Subject: Fw: Re: PL/2026/00753 - Mill Ground, 30 Mill Road, Worton

Further to my telephone conversation with you earlier. There are some strong concerns regarding the impact of the proposed gable roof extension at this property in terms of it having an oppressive impact upon the outlook of the private sitting out space of the occupiers of the neighbouring dwelling at 32 Mill Ground, in addition to a loss of sunlight into this area and the secondary window to the lounge, facing this shared boundary. This is due to its position, length, height and the steep incline of the proposed additional roof structure. It is noted that their rear garden faces north and therefore, they currently enjoy sunlight in the shape of a 'W' either side of the gable end roof of the main section of the bungalow into this area. It is noted that the occupier at No. 32 Mill Ground has objected to the proposals for similar reasons to those set out above.

The rudimentary sun path below shows this.

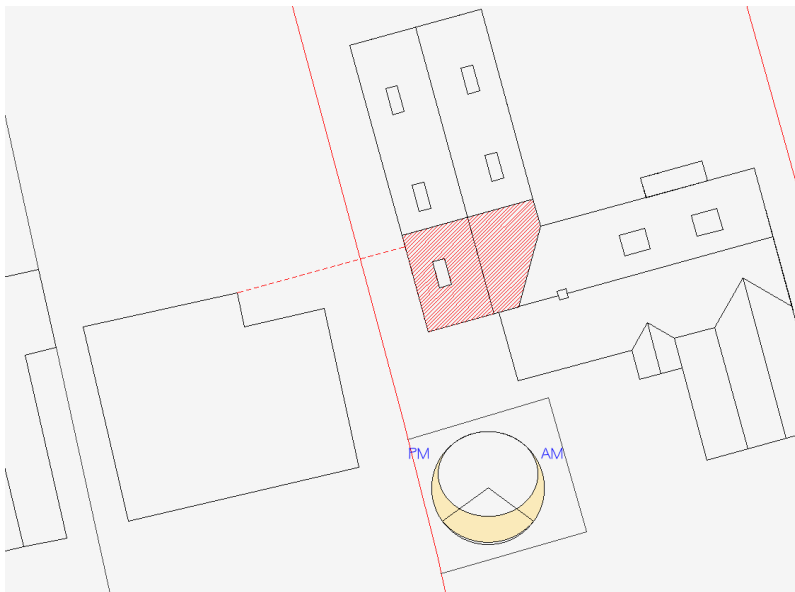
I do not think this has been considered from "our side of the fence "

The proposed extension is adjacent to the neighbour's house.

The photographs you provided clearly show that any shadowing is from their own house, not my clients.
